FINAL DRAINAGE PLAN

THE RIDGE AT LORSON RANCH

FILING NO. 1: SF 22-004

JANUARY, 2022
REV. MARCH, 2022
REV. JUNE, 2022

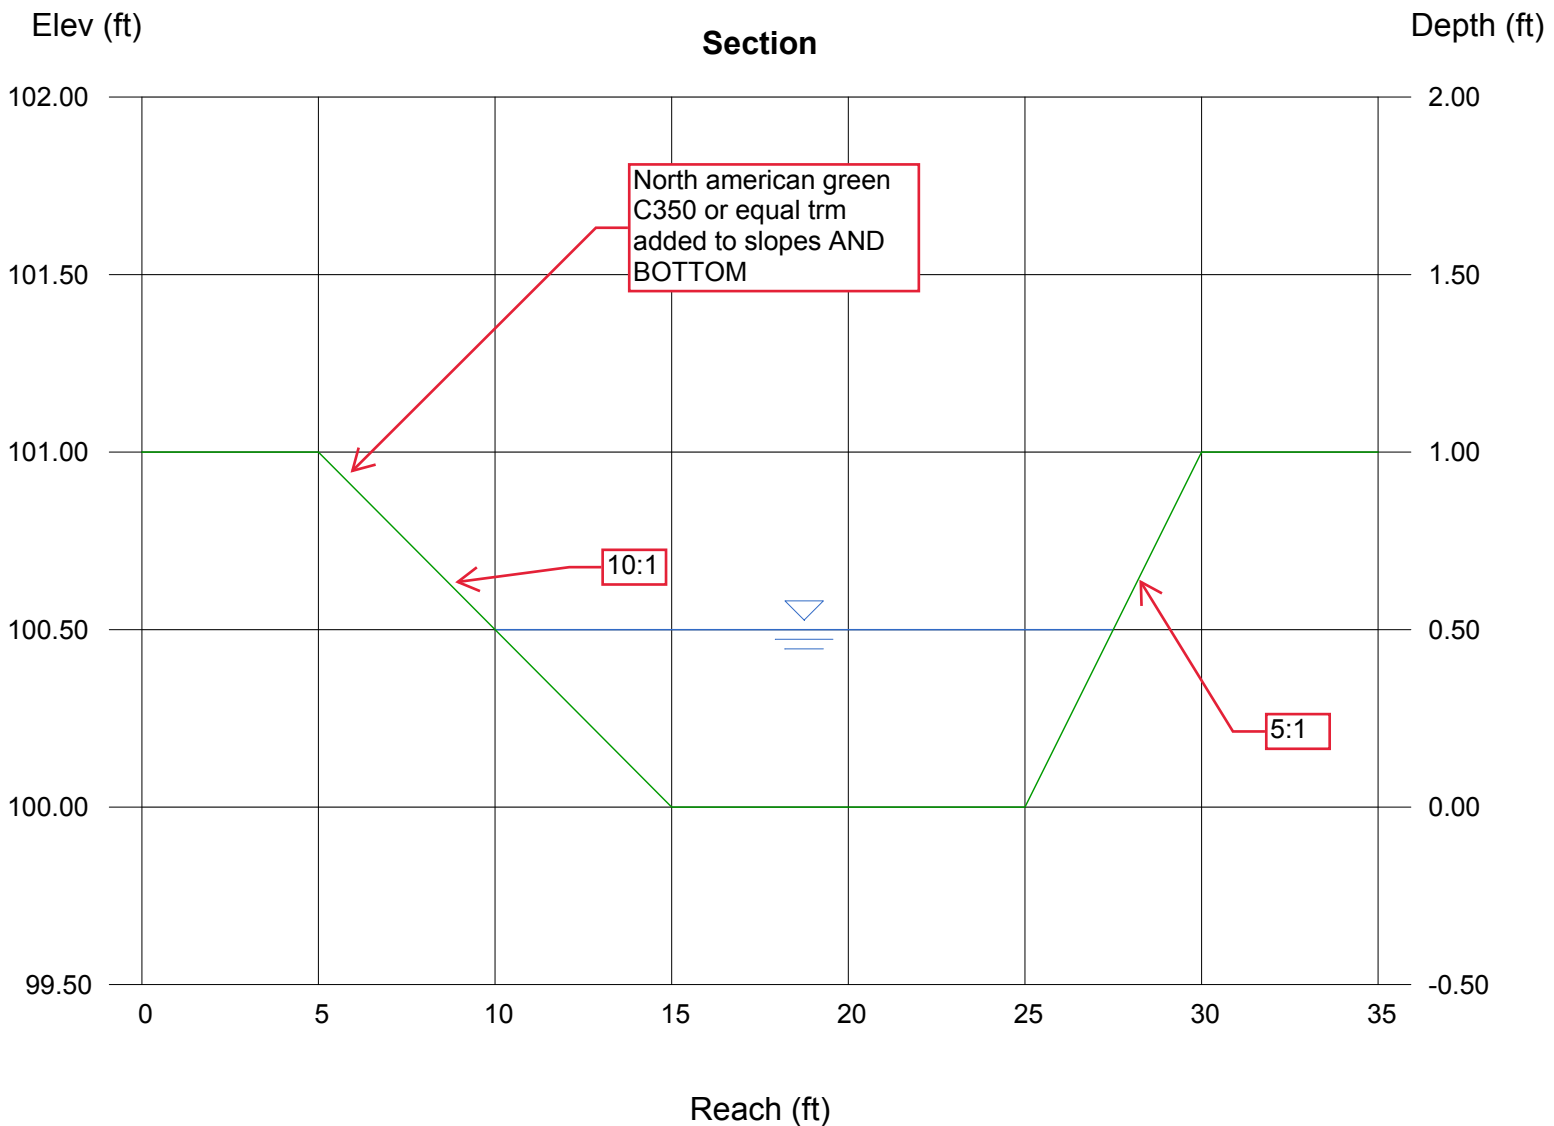
10:1 AND
5:1.
SEE
SECTION

APPENDIX D – POND AND ROUTING CALCULATIONS

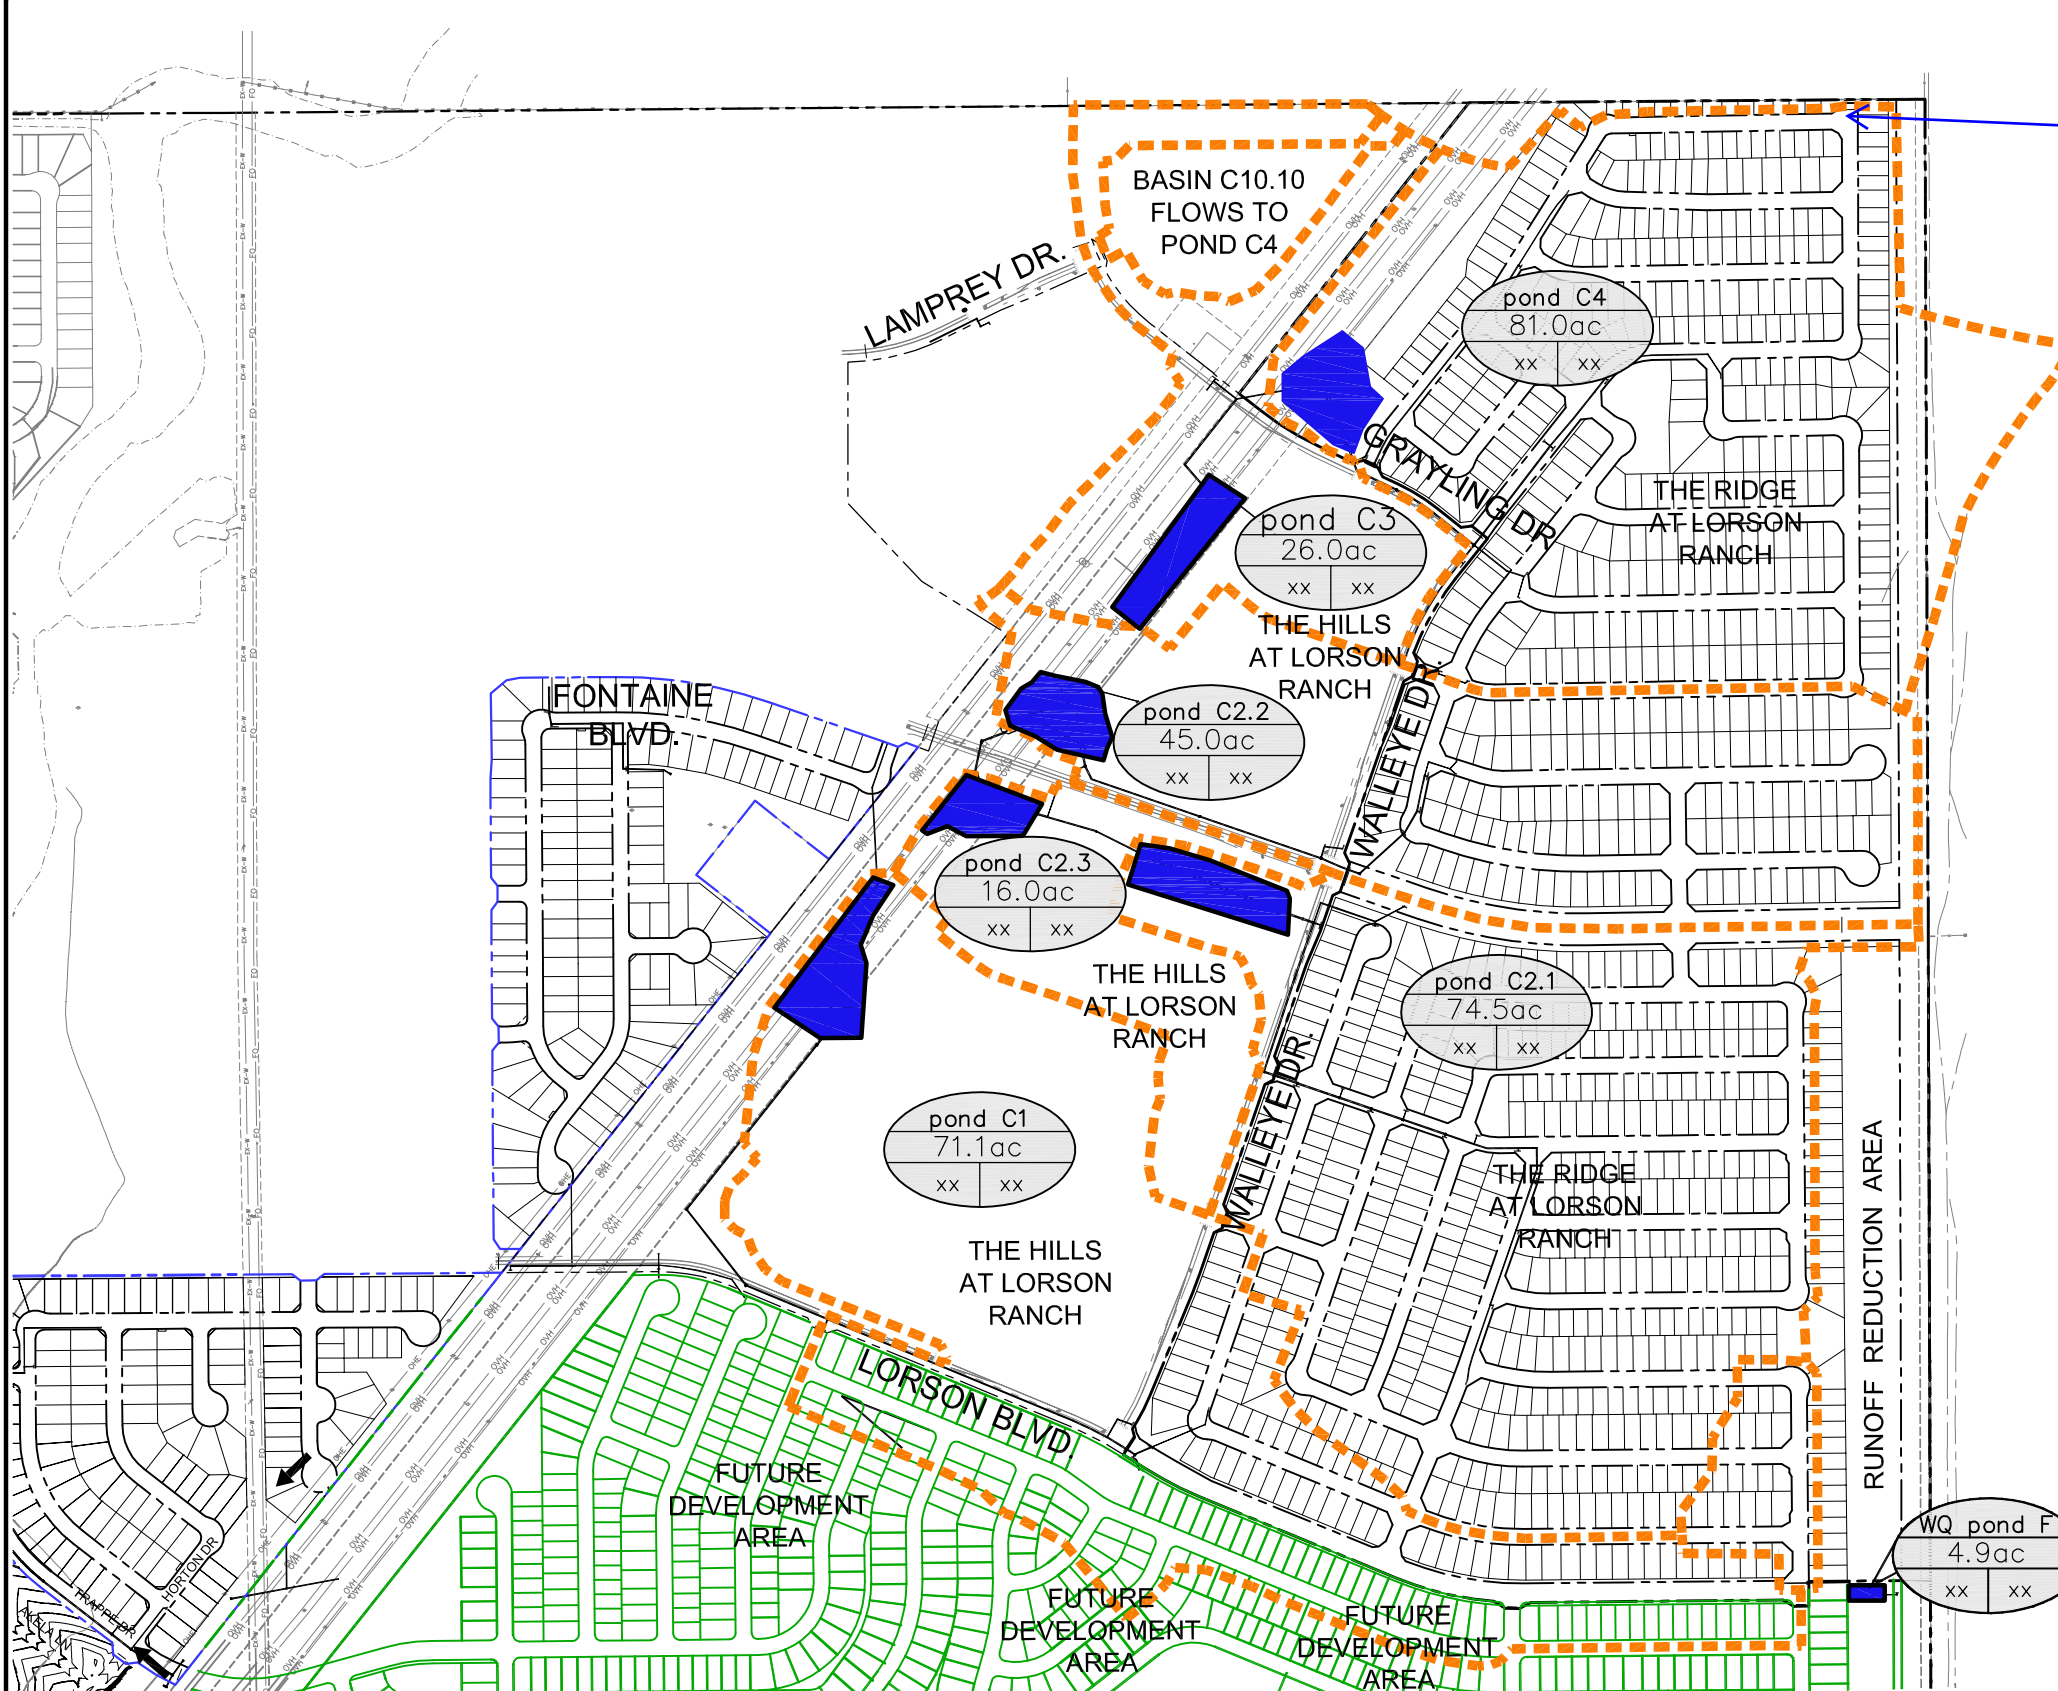
Doesn't match revised drainage plan

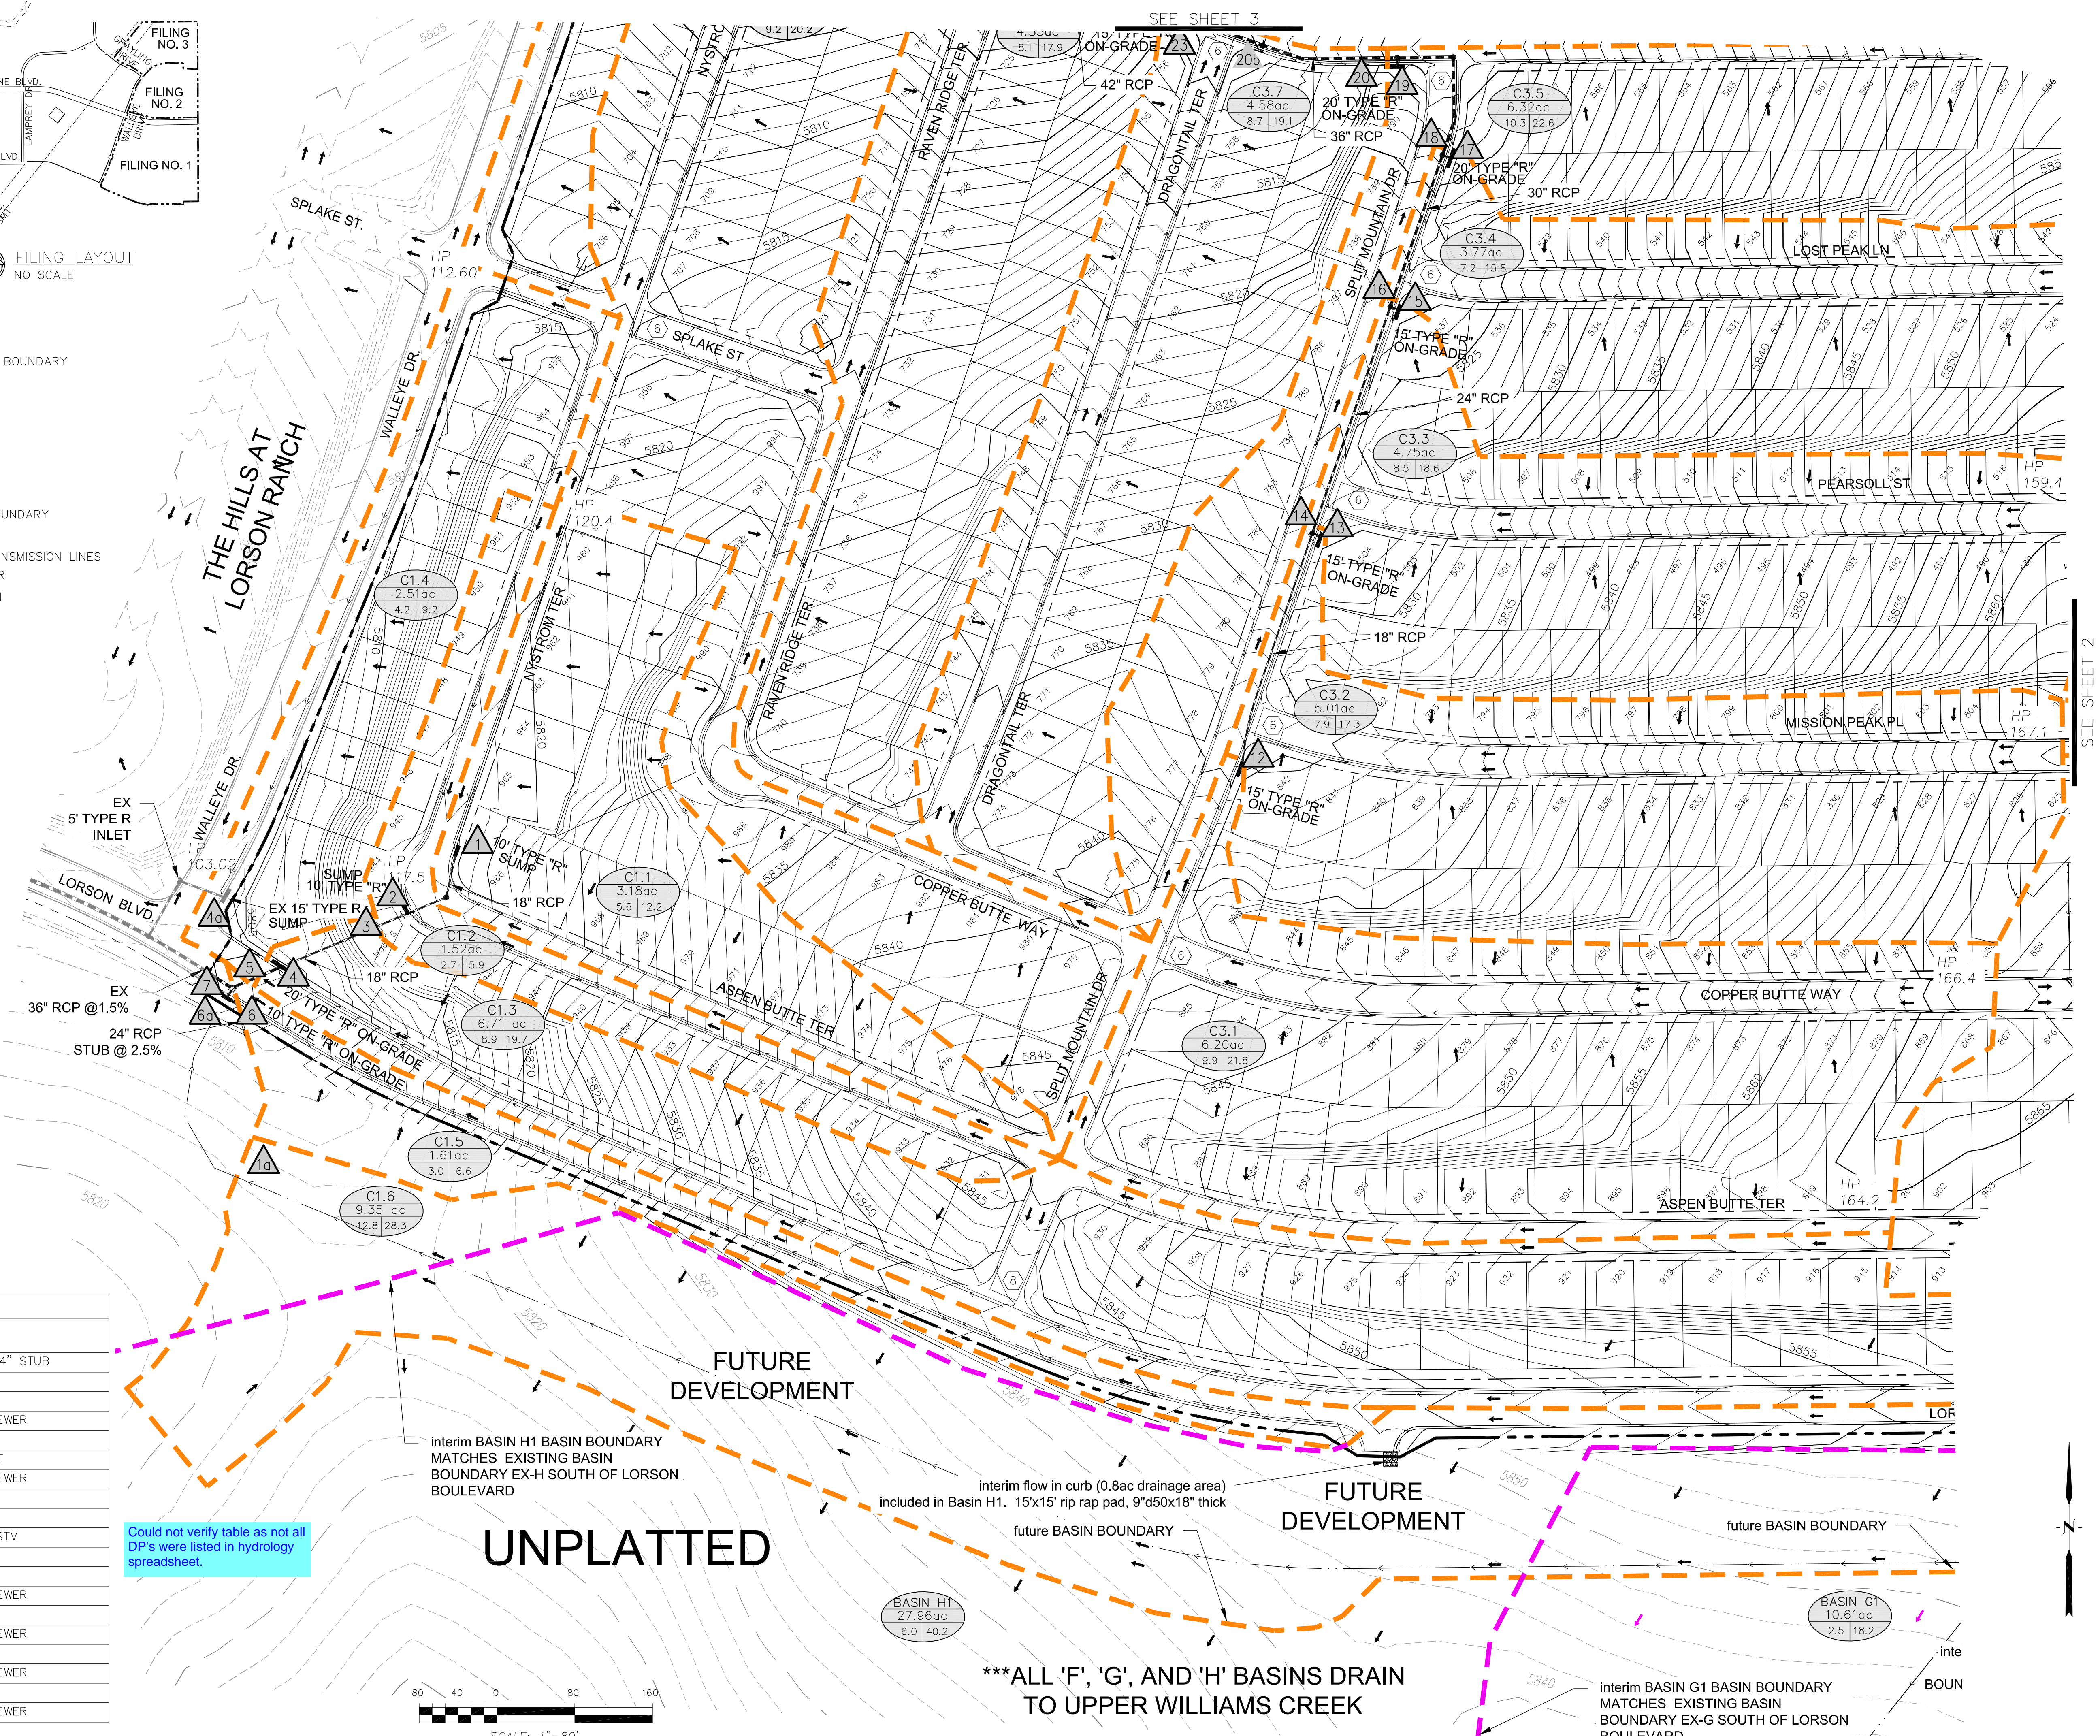
Could not verify table as not all DP's were listed in hydrology spreadsheet.
